5.3 NO. 52 (LOT: 10; D/P: 1069) BOURKE STREET, LEEDERVILLE - PROPOSED TWO GROUPED DWELLINGS

RECOMMENDATION:

That Council, in accordance with the provisions of the City of Vincent Local Planning Scheme No. 2 and the Metropolitan Region Scheme, **APPROVES** the application for Two Grouped Dwellings at No. 52 (Lot: 10; D/P: 1069) Bourke Street, Leederville, in accordance with the plans shown in Attachment 2, subject to the following conditions, with the associated determination advice notes in Attachment 7:

GROUND FLOOR PLAN
1:100

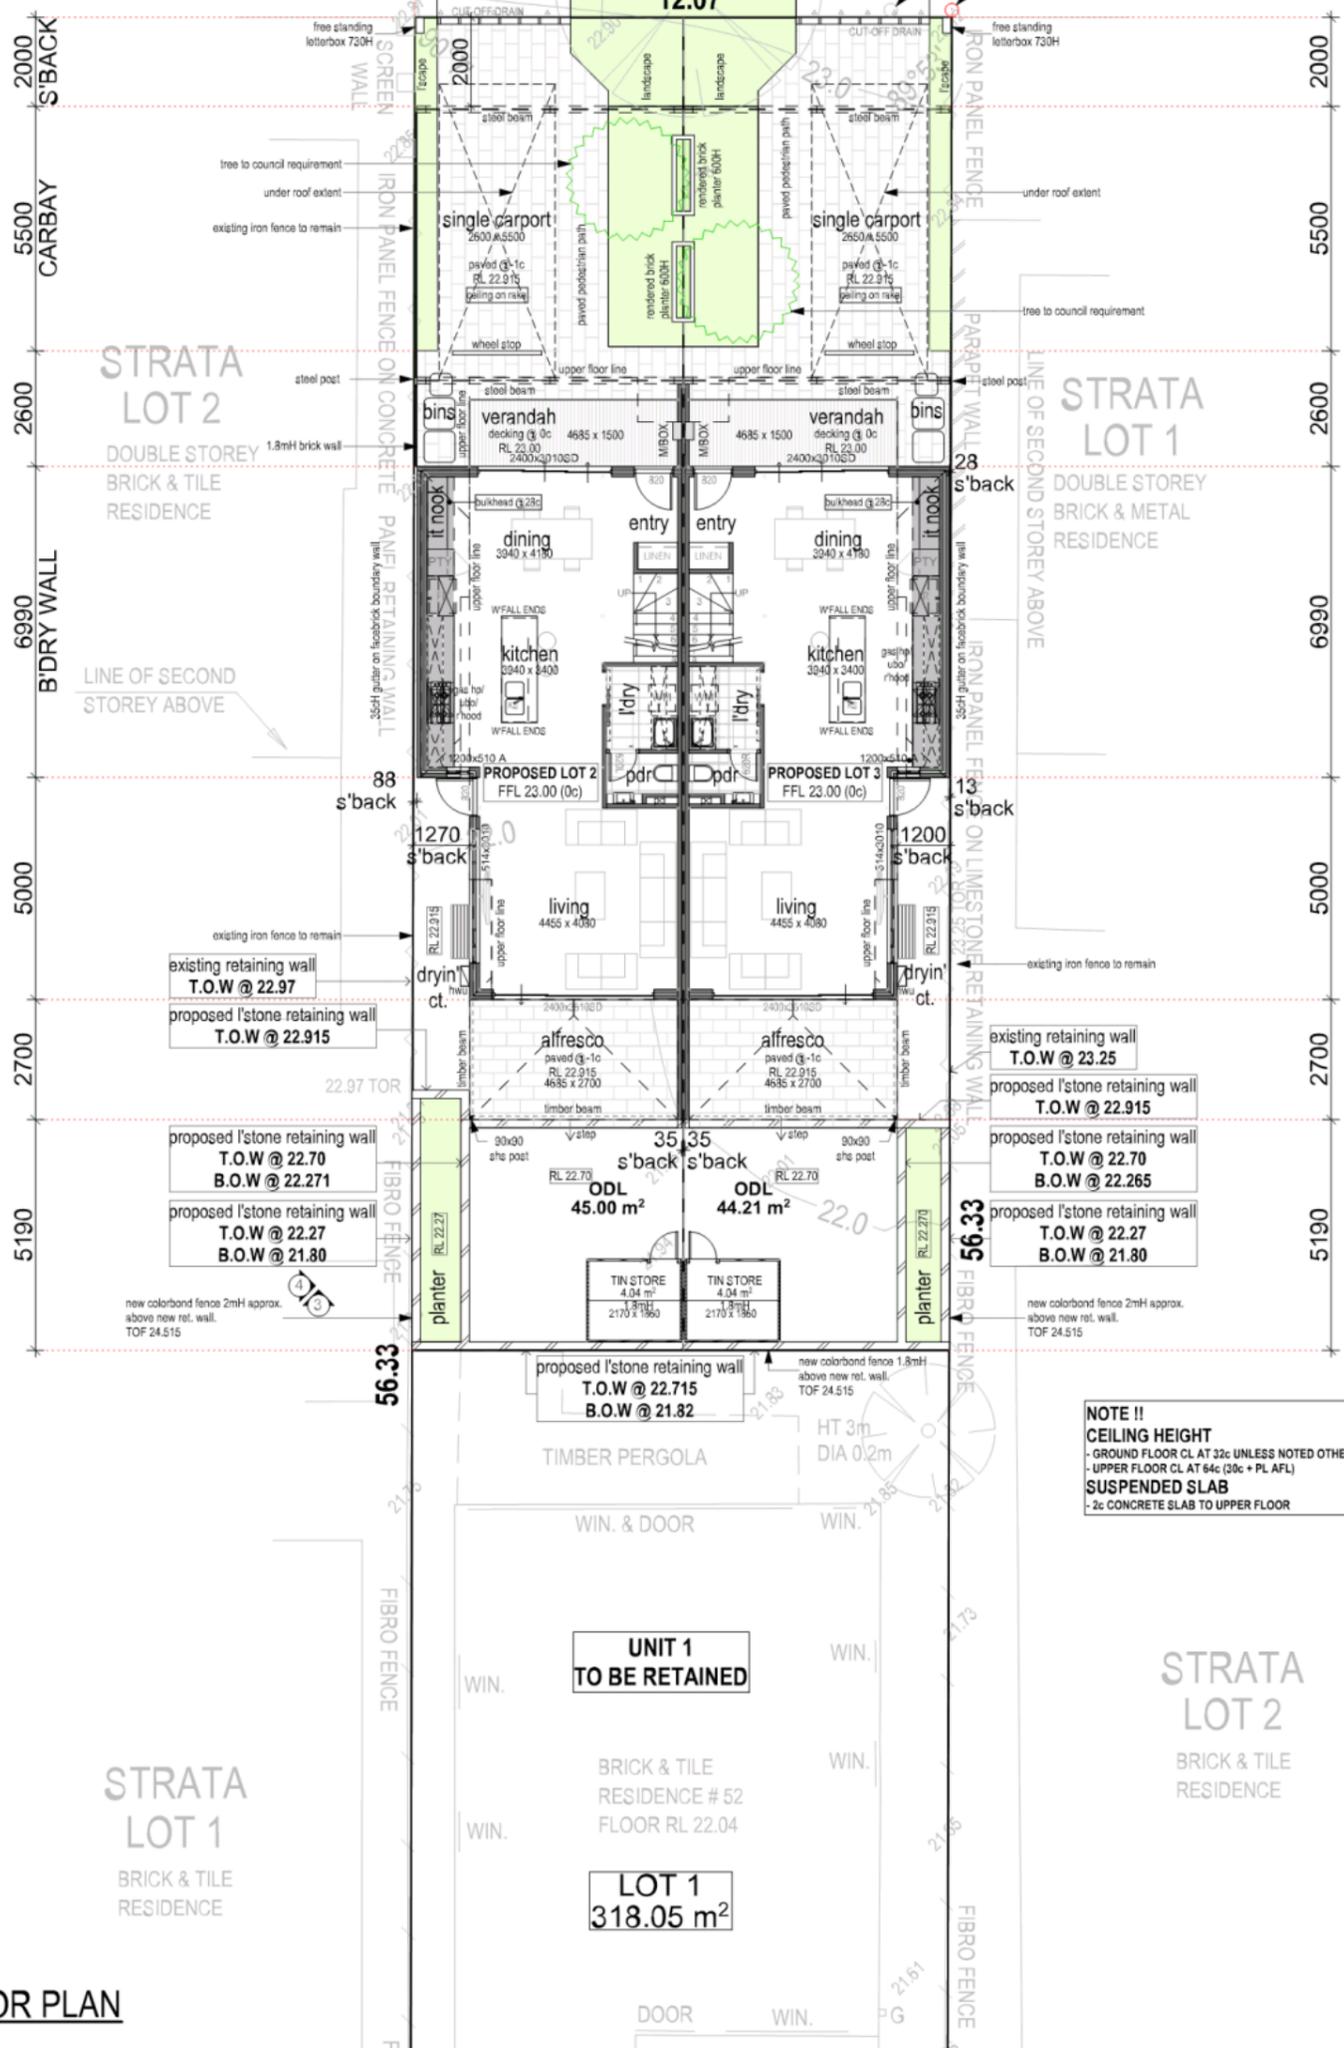
- The further reduction in the carport and crossover widths are a positive change which are supported;
- The additional landscaping in what was previously the double carport area is supported. Given the site is significantly under the canopy coverage standard a significant sized tree should be planted in this area;

After the second round of consultation, two trees and the associated canopy coverage were added to the plans in the street setback area of the dwellings. These plans are included as **Attachment 2**. Apart from this change these plans are the same as the plans advertised during the second round of consultation.

PROJECT INFO:
FG SG DA
DRAWN BY: ET CHKD BY: YL
SCALE: 1:200 @ A3 NORTH
DRAWING TITLE: LANDSCAPING/STORMWATER PLAN
DRAWING NO. A05 REVISION: DA4

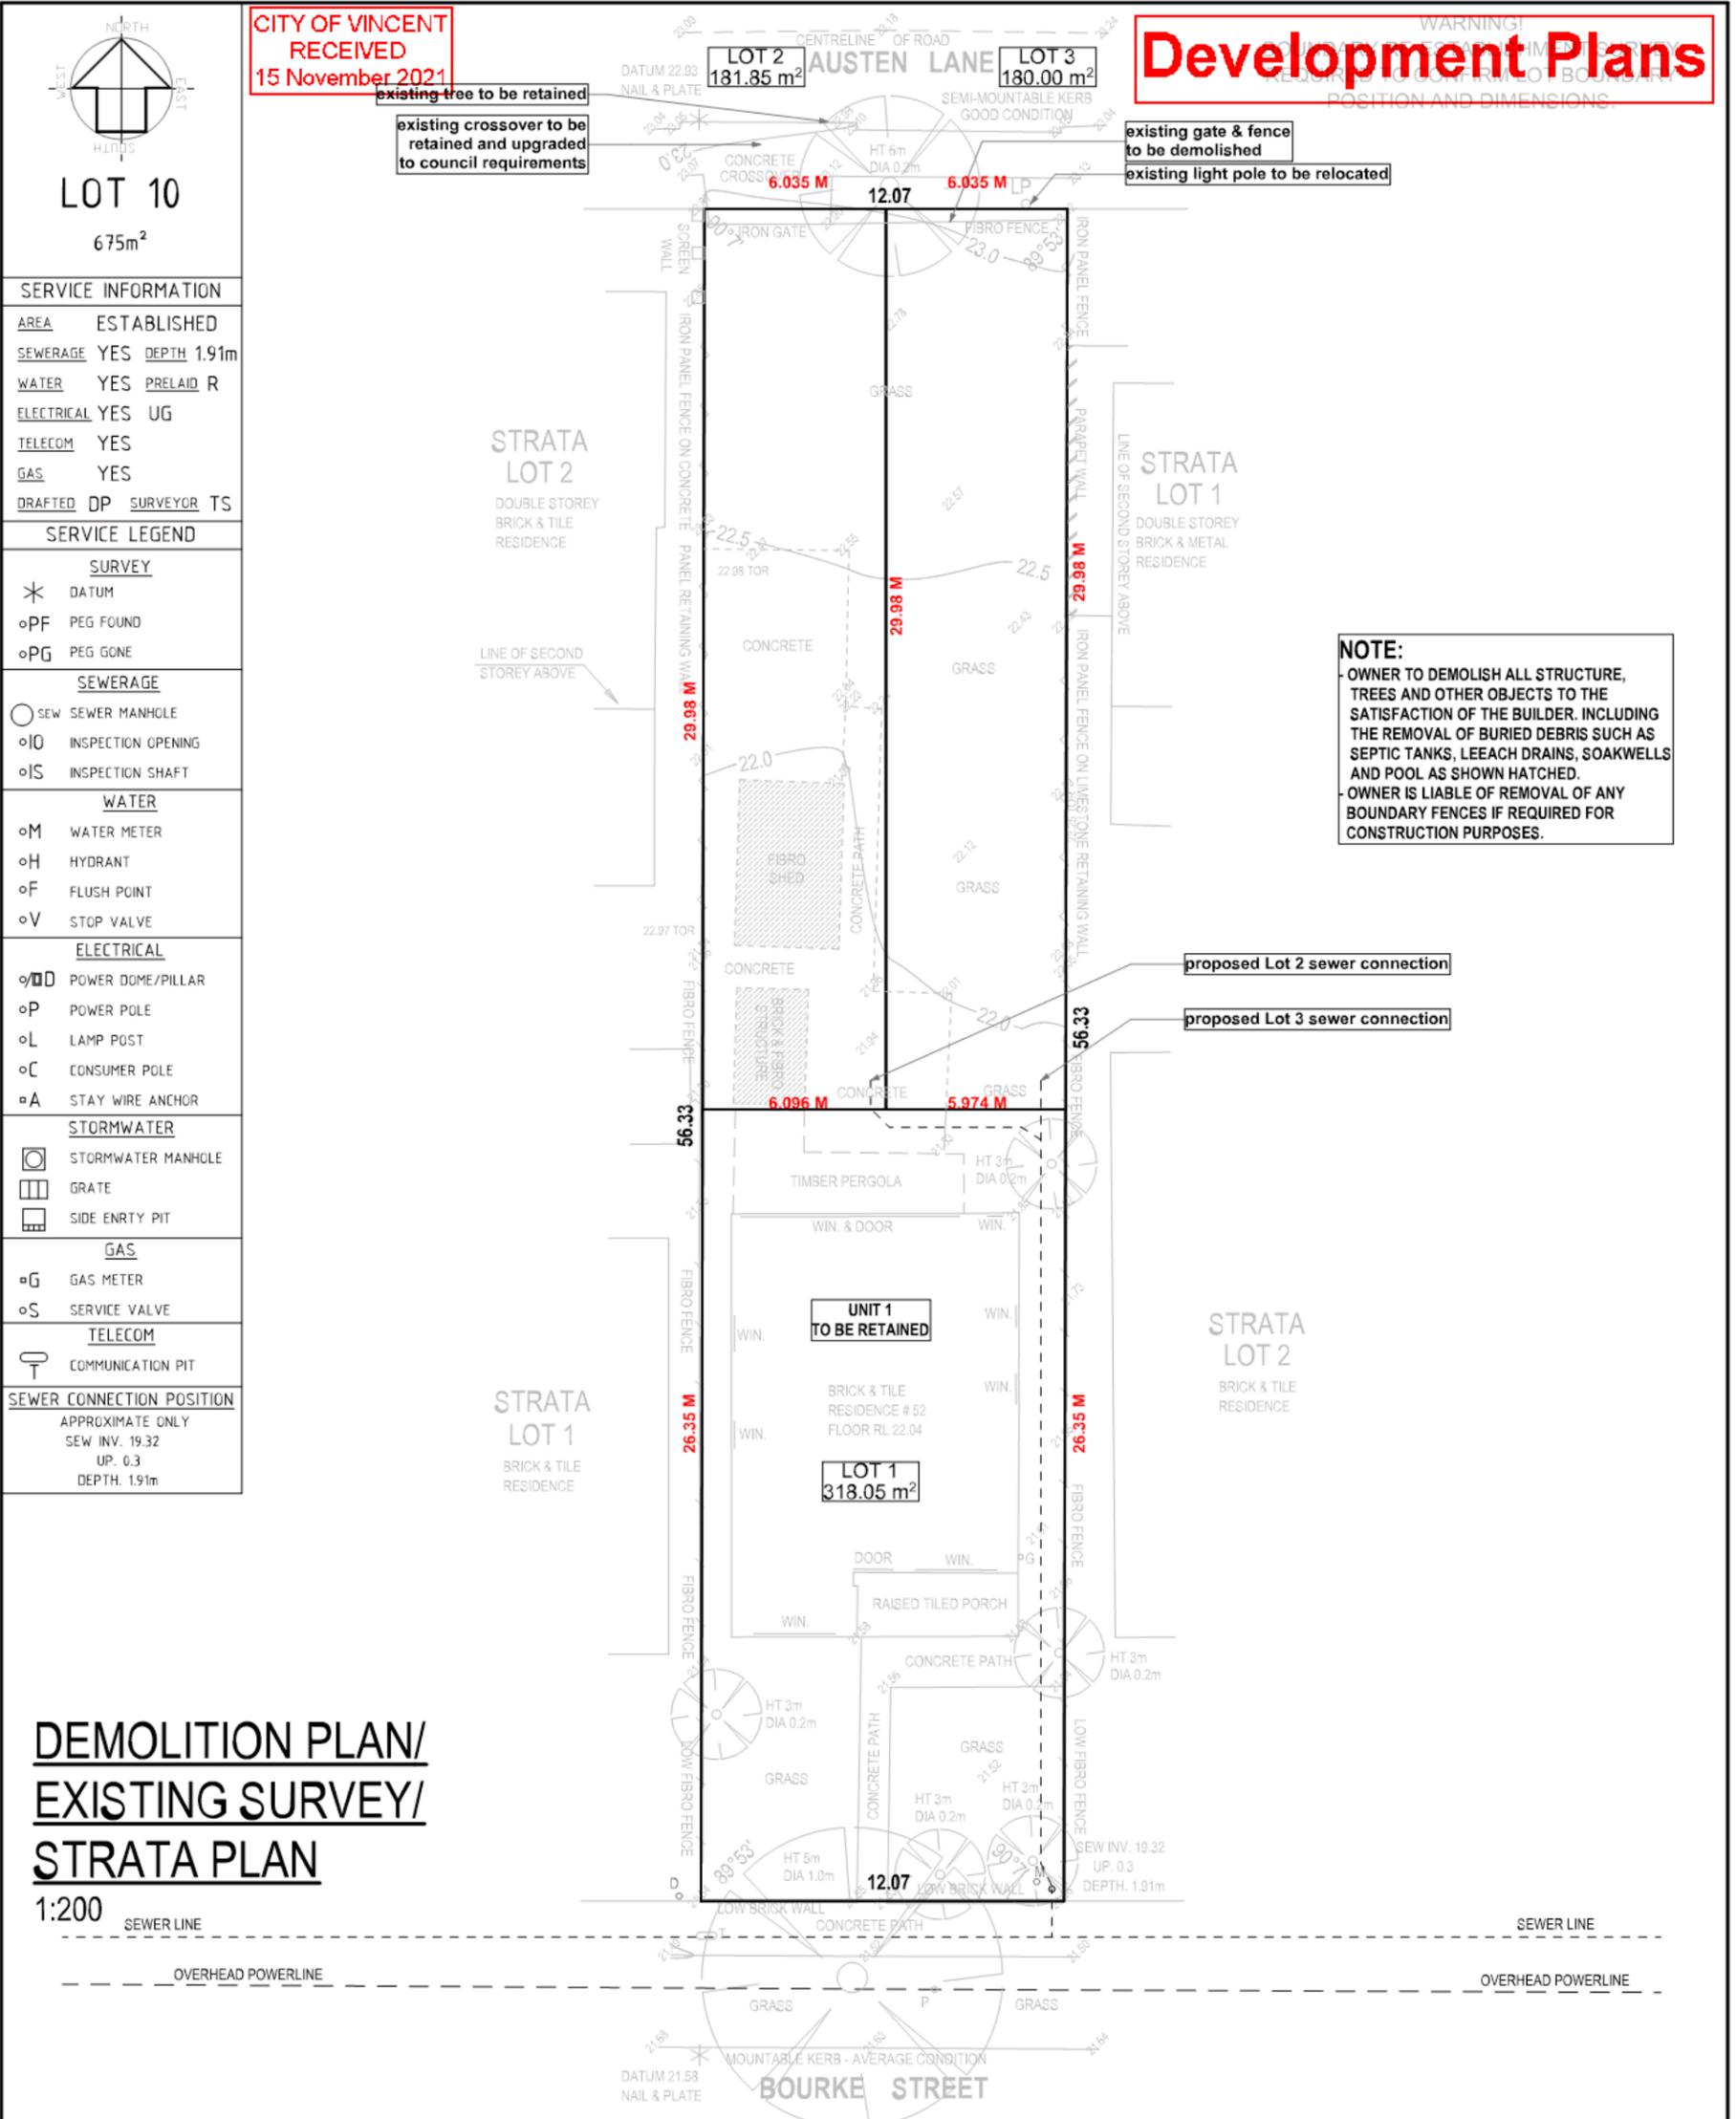
- As this is a rear laneway interface and the proposed carport is very open, the front (laneway) setback variations are supported;
- The canopy coverage of both dwellings should be increased by planting significant size new trees in the new landscaped area within the front setback area;

- The amendments made are generally positive and supported. As per the initial comments, there are a number of positive aspects to the proposal generally resulting in a high level of amenity for future residents. The proposal is supported conditional on canopy coverage being increased by planting two new significant sized trees in the front setback area.

In response to the final DRP comments amended plans were submitted which added two trees and associated canopy coverage to the street setback area. No other changes were made and the final development plans are included as **Attachment 2**.

- The existing verge tree is to be retained and provides canopy that extends to within the street setback areas for the units. Two new *Eucalyptus ficifolia* trees are proposed in the street setback areas of Units 2 and 3. The City's Tree Selection Tool states that these trees would have a canopy width at maturity of 5.0 metres, rather than the canopy width of 2.5 metres shown on the plans, ensuring that these trees would provide additional canopy coverage compared to what is indicated on the plans. Two new *Plumeria rubra* trees are proposed at the rear of the sites, but the City's Parks team has recommended that these be replaced with *Crepe Myrtle* (*Lagerstroemia indica*) trees which would have a canopy width at maturity of 8.0 metres. The canopy coverage calculation includes this change and a condition has been recommended accordingly to require this change to be made. These trees would maximise canopy coverage, make an effective contribution to the City's green canopy and soften the appearance of the dwellings from the adjoining properties and from Austen Lane. This is complemented by the smaller shrubs and plants proposed within the planters in the street setback area;
